CREEKWOOD SUBDIVISION, UNIT III

APPLICATION NUMBER Holdover DATE February 1, 2007
APPLICANT Creekwood Subdivision, Unit III
REQUEST Subdivision

DETAIL SITE PLAN

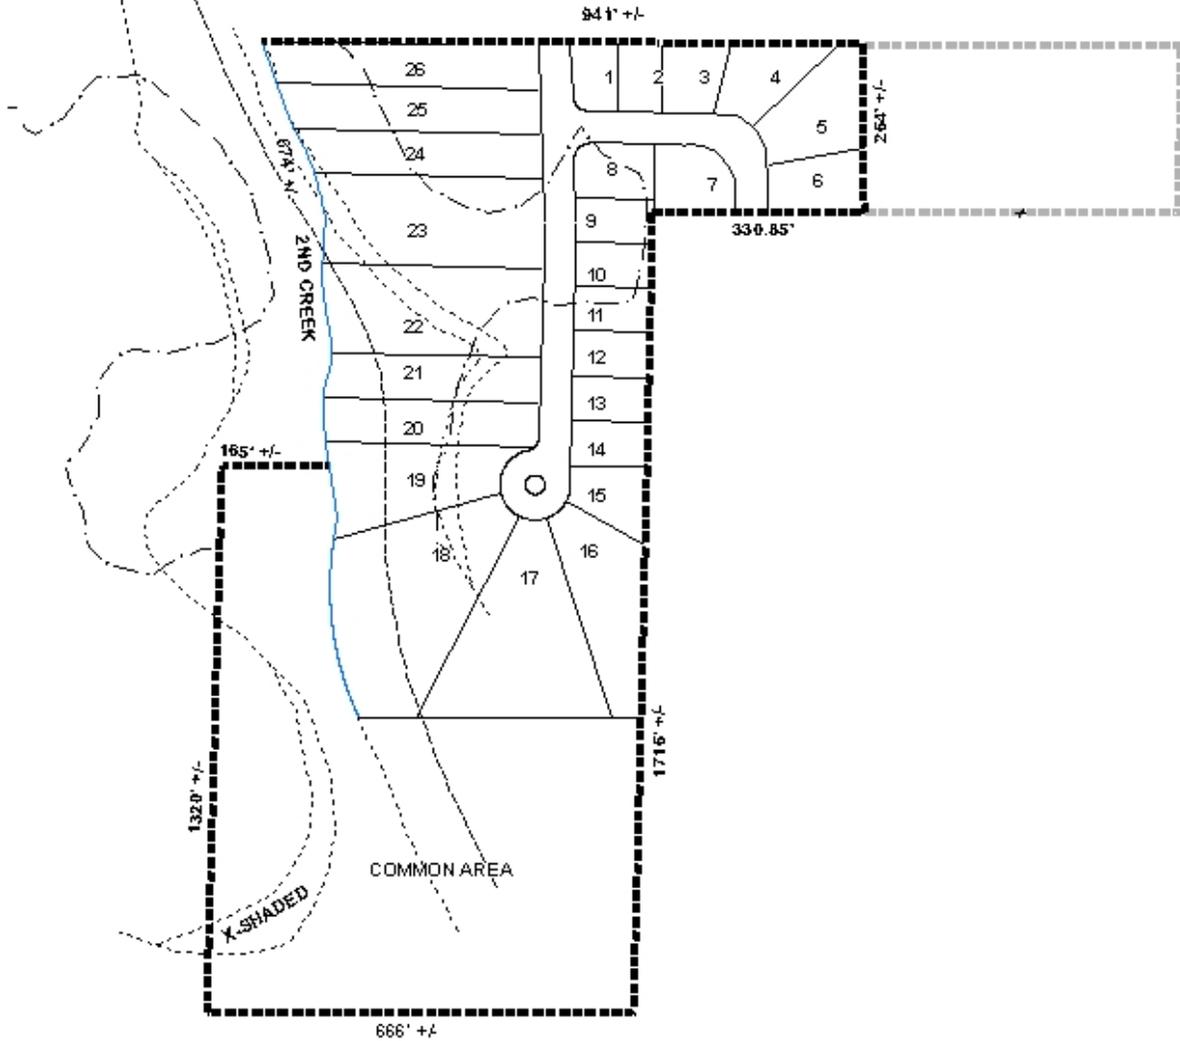
All proposed lots appear to meet minimum dimensional requirements, however, lots 18 through 24 appear to have up to just over half the lot encumbered by the floodplain for a branch of Second Creek. Several lots also appear to be impacted by the floodway associated with Second Creek.

Both proposed “future development” areas appear to be encumbered by floodplains, and the presence of branches of Second Creek as well as the topography appear to limit the applicant’s options regarding future development. It should be pointed out that the eastern “future development” area appears to be landlocked, thus the plat should be revised to at minimum show a dedicated access to each “future development” area from the public right-of-way so that maintenance vehicles can access the areas. Due to the environmental constraints, it would appear more likely that the “future development” areas will become unmaintained common areas.

The 25-foot minimum building setback line, required in Section V.D.9., is not shown for the subdivision, but would be required on the final plat, if approved.

A revised plat was received showing access to one adjacent land-locked parcel, but no longer showing the “future development” area to the East, thus not including the remainder of a lot/parcel and leaving it in a “land-locked” condition. The plat was not revised to include the remainder of the parcel to the West, as requested, nor was any information provided regarding the prior division of land without the subdivision process. Furthermore, additional research by staff shows that a portion of the site under consideration is part of an approved subdivision that has not yet been recorded (Pine Valley, Second Addition), and that will not expire until June 2007.

Based upon the preceding, the application is recommended for Denial for the following reasons: 1) the sale of the remainder of parcel R023303062000001. (West side of Second Creek, specifically the portion of Lot 1 of Wellsville Farms) occurred without the appropriate subdivision process; 2) the remainder of parcel R023303061000002. will be land-locked, and is not accounted for in the proposed subdivision; 3) there is no provision of access to most of the adjacent land-locked parcels; and 4) the proposed subdivision is utilizing land currently part of an existing approved but unrecorded subdivision.
